*Date:* **OCT 08 2015**  
*Symbol:* ENV-DO-15-0274  
*LA-UR:* 15-27555  
Locates Action No.: NA

**Subject: Request for Additional Information, Class V Underground Injection Control Wells, Discharge Permit Application DP-1835**

Injection well operation schematic

# INJECTION WELL OPERATION SCHEMATIC

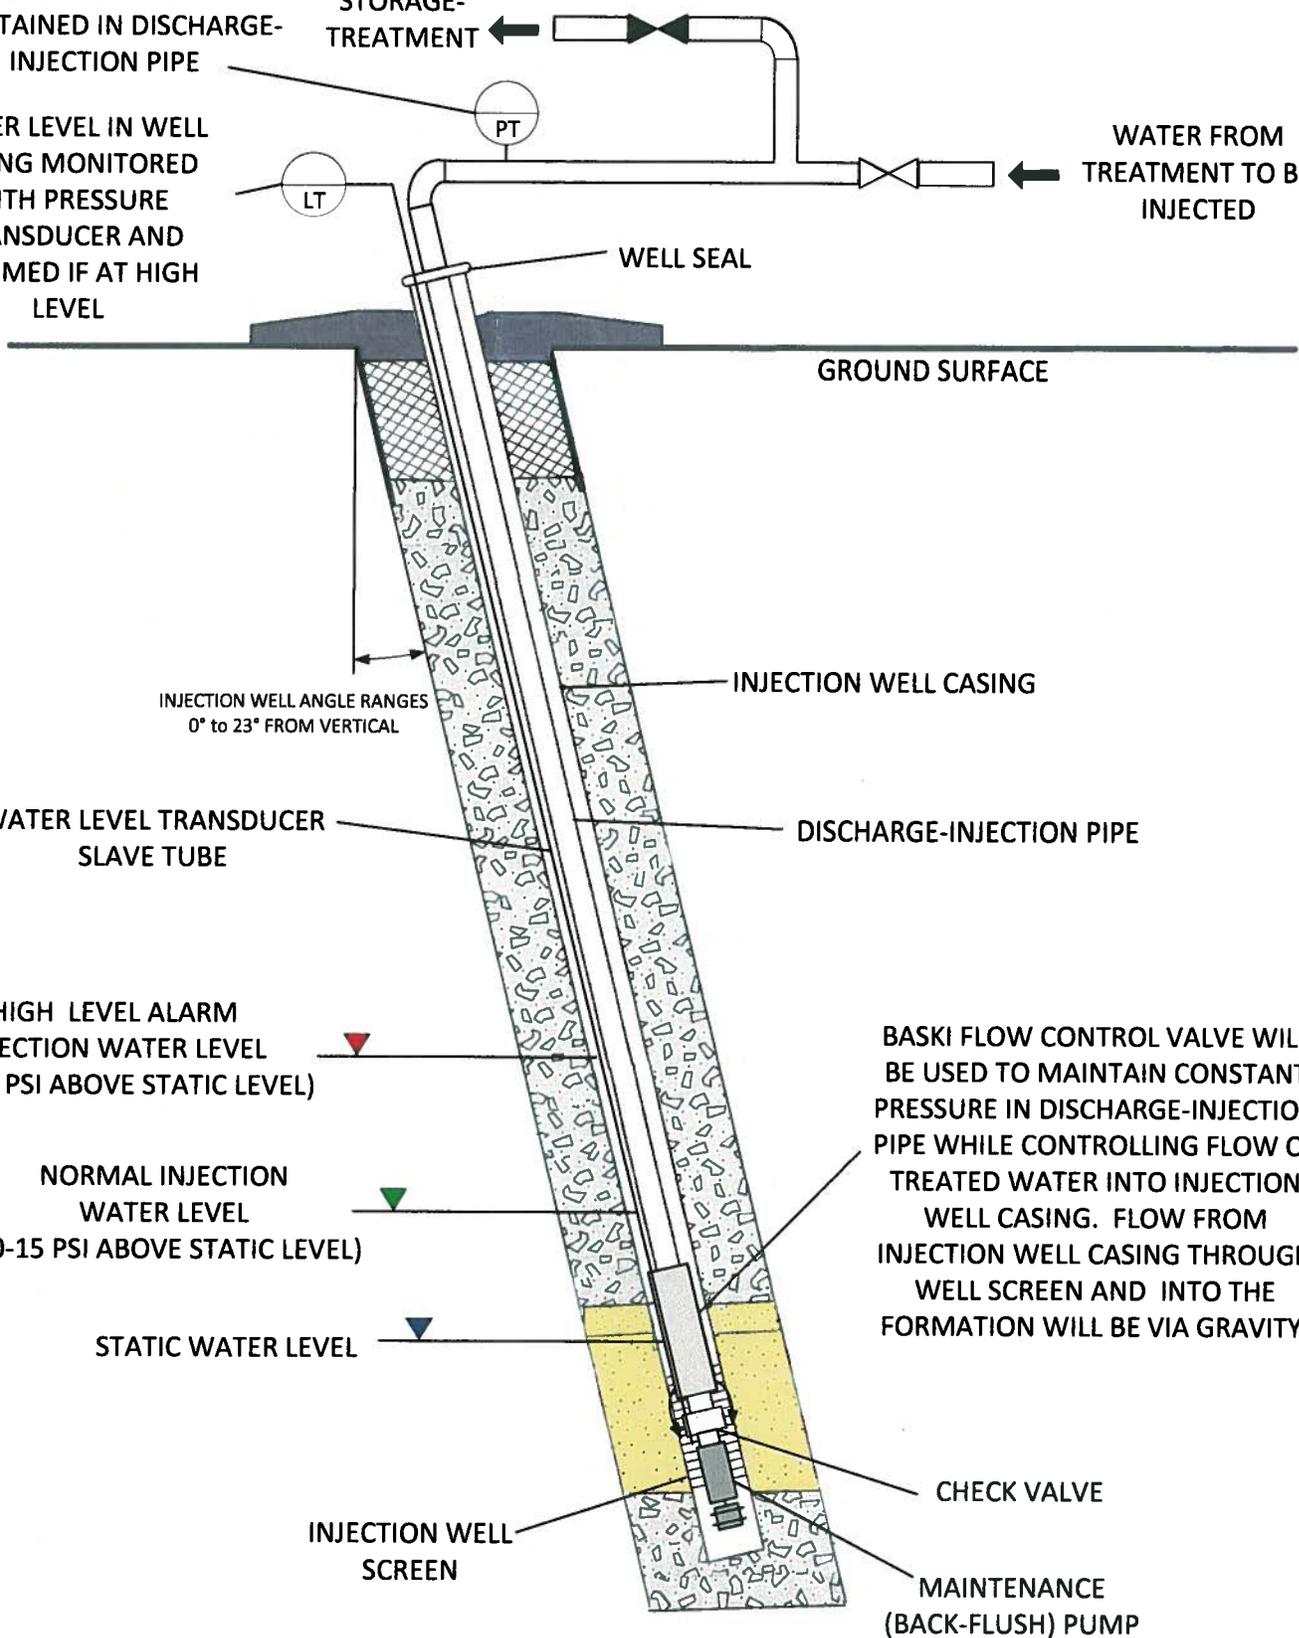
- ✓ **Additional information on injection well design and operation.** The injection well design schematic provided in Appendix B of the April 2015 discharge permit application (ENV-DO-15-0085) should be modified to include the following additional information: (a) the normal and maximum operating pressures, (b) the possible degrees from vertical of injection wells drilled at an angle, and (c) identification of the Baski, Inc. flow control valve (FCV™). In addition, a more detailed description of how the injection wells will be operated is needed.

PRESSURE MONITORED AND MAINTAINED IN DISCHARGE-INJECTION PIPE

WATER LEVEL IN WELL CASING MONITORED WITH PRESSURE TRANSDUCER AND ALARMED IF AT HIGH LEVEL

HIGH LEVEL ALARM INJECTION WATER LEVEL (35-45 PSI ABOVE STATIC LEVEL)

BASKI FLOW CONTROL VALVE WILL BE USED TO MAINTAIN CONSTANT PRESSURE IN DISCHARGE-INJECTION PIPE WHILE CONTROLLING FLOW OF TREATED WATER INTO INJECTION WELL CASING. FLOW FROM INJECTION WELL CASING THROUGH WELL SCREEN AND INTO THE FORMATION WILL BE VIA GRAVITY.

NORMAL INJECTION WATER LEVEL (10-15 PSI ABOVE STATIC LEVEL)
